**AGENDA
PLANNING & ZONING COMMISSION
THURSDAY, November 14, 2019
7:00 P.M. TOWN HALL**

TITLE: Continued Public Hearing - Sopris Lofts – 1201 Colorado Avenue
Major Site Plan Review, Conditional Use Permit, Alternative Compliance
and an Amendment to Ordinance No. 18, Series of 2016

LU19-20-20 Stein 133 and Main - Major Site Plan Review - RESPONSE

TITLE: Sopris Lofts – 1201 Colorado Avenue
Major Site Plan Review and Conditional Use Permit

NORTH ELEVATION

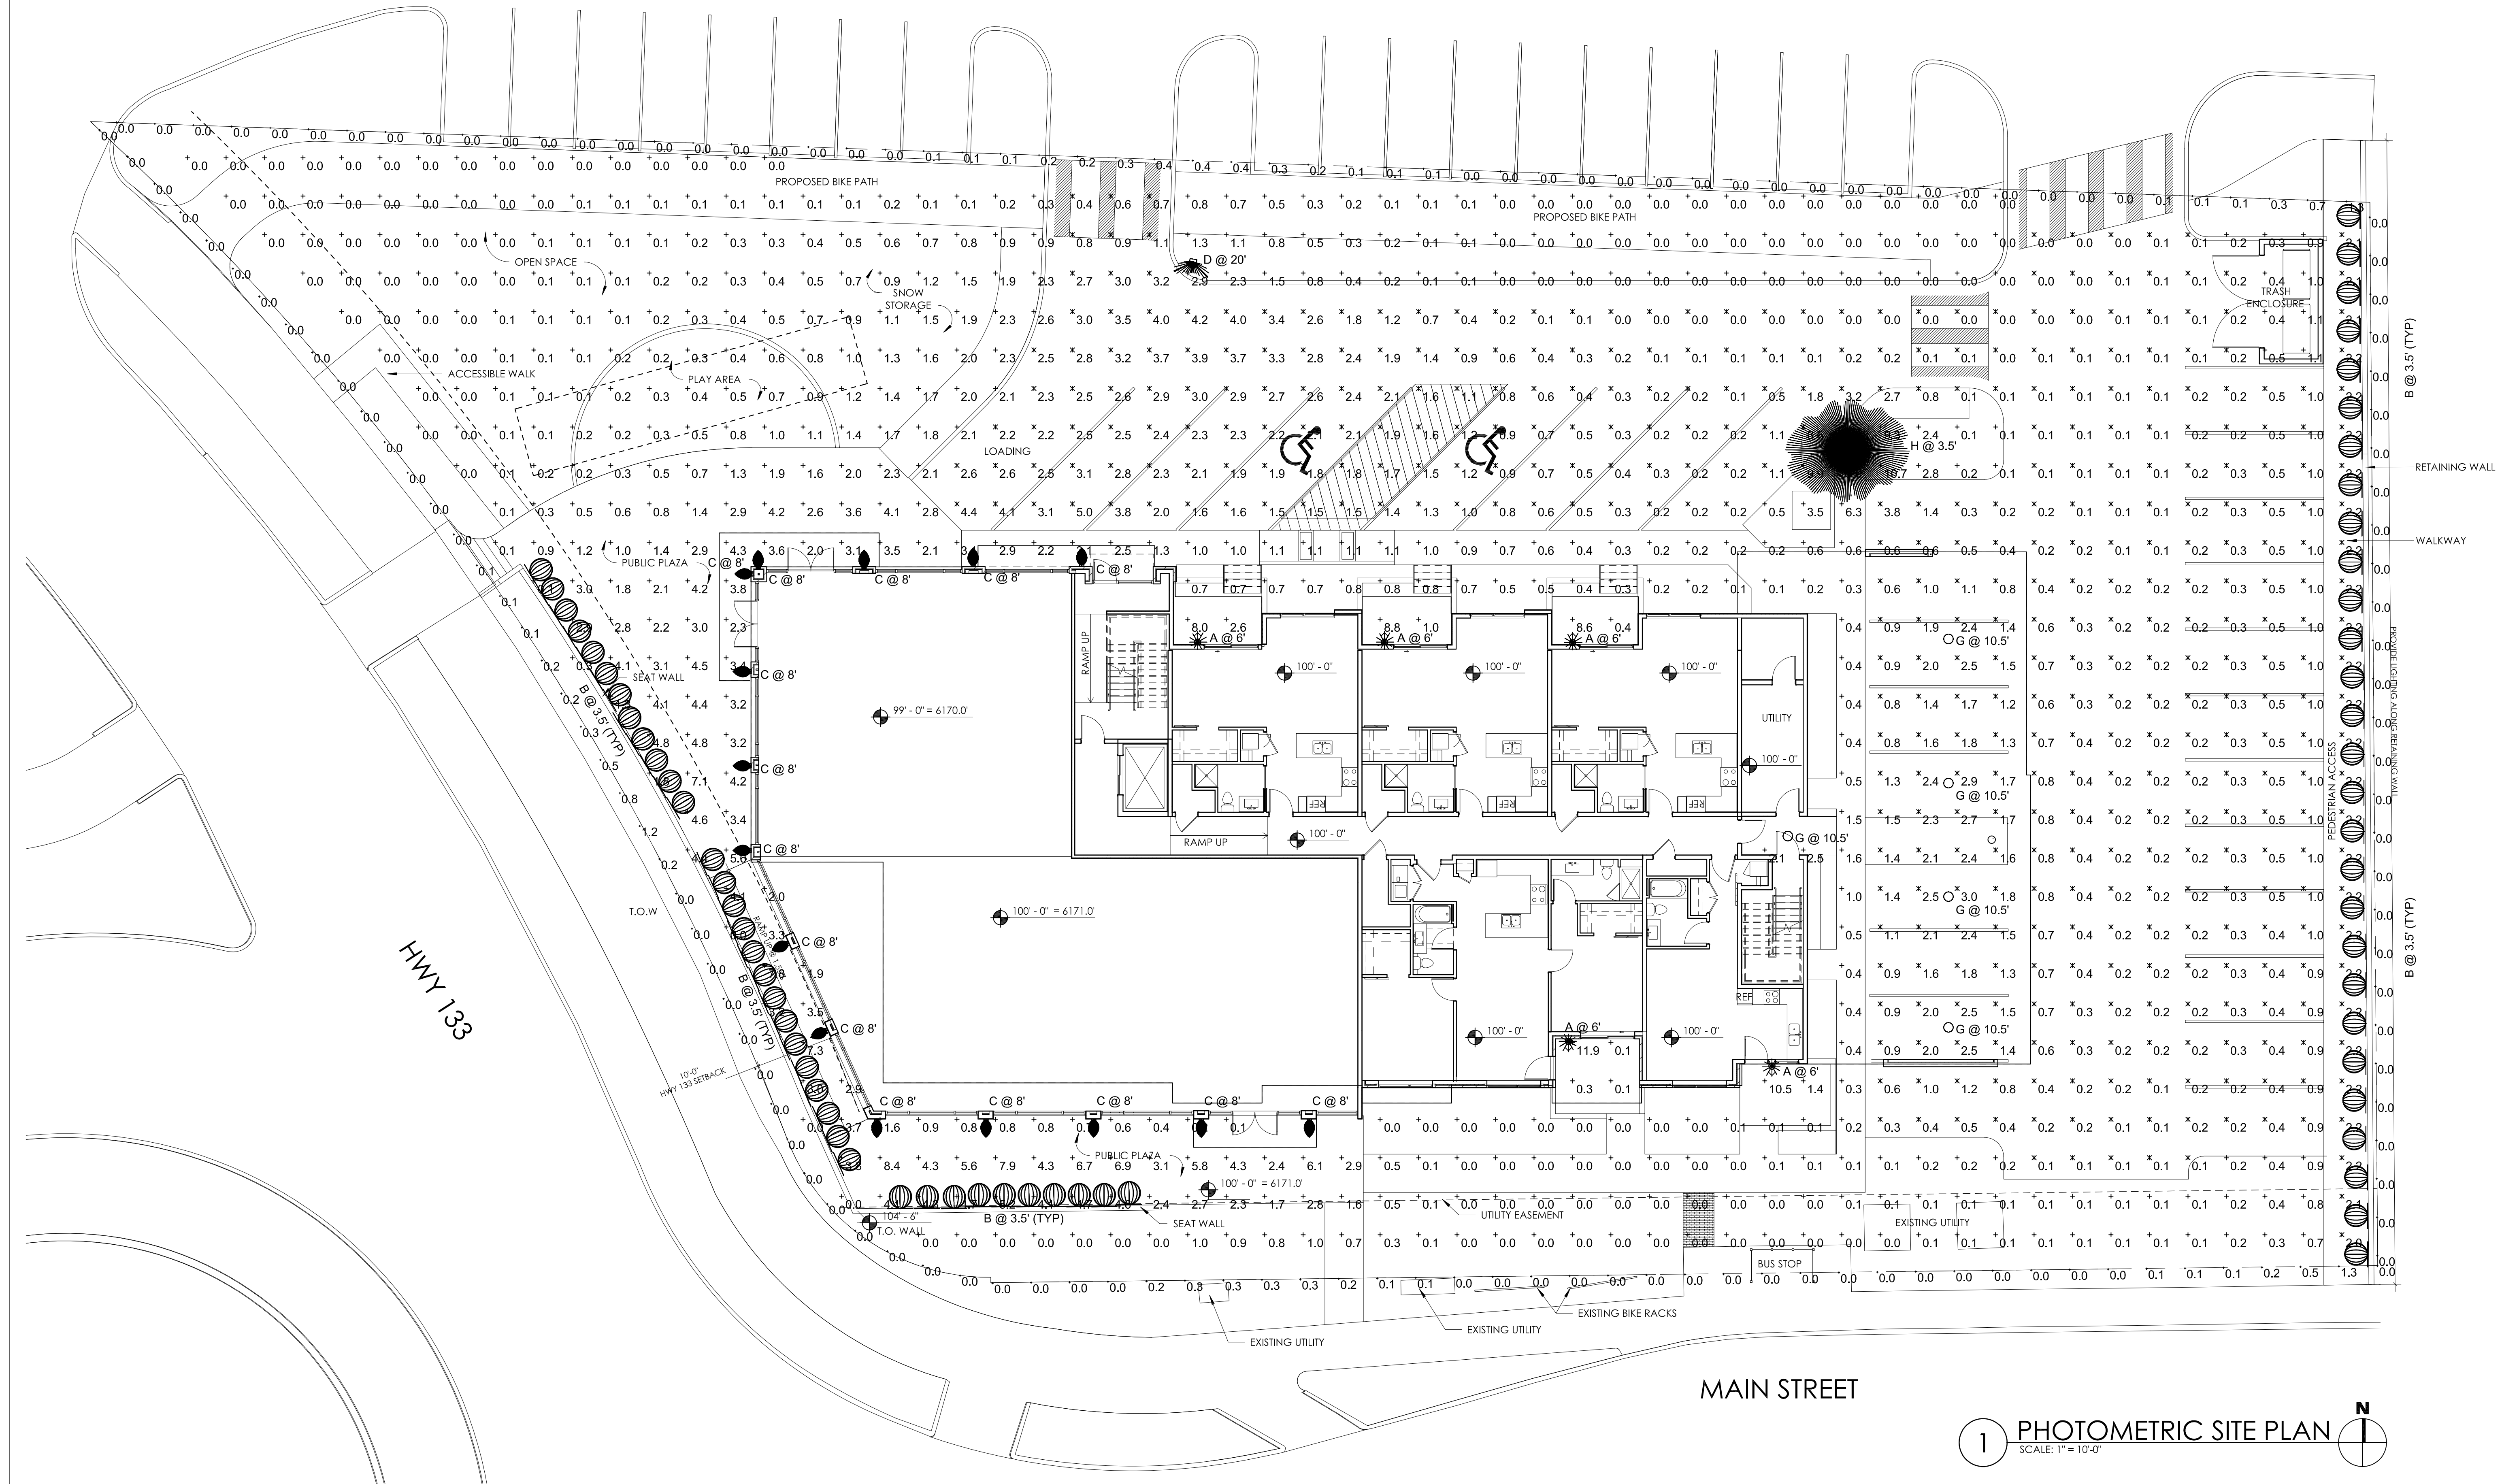
There are a number of code sections related to building design which Staff has listed below which need additional attention. Staff does not feel that the commercial portion of the building along Highway 133 and Main Street is in compliance with these sections. There are also some questions about the building overall as it relates to horizontal articulation and the roofline. Many of these code sections are duplicative because of the various design standards which apply to mixed-use buildings.

The main entrance for residents facing Colorado Ave. has been recessed from the primary building plane. The recessed entry is distinguished from the commercial entries which have canopies. Refer to renderings in Exhibit 6 that illustrate changes in materials, colors and textures around the building. Refer to Exhibit 5 for updated plans and elevations.

The main entrance for residents along Colorado Ave. has been revised with a recessed storefront. Please refer to the North West rendering for an illustration of these changes.
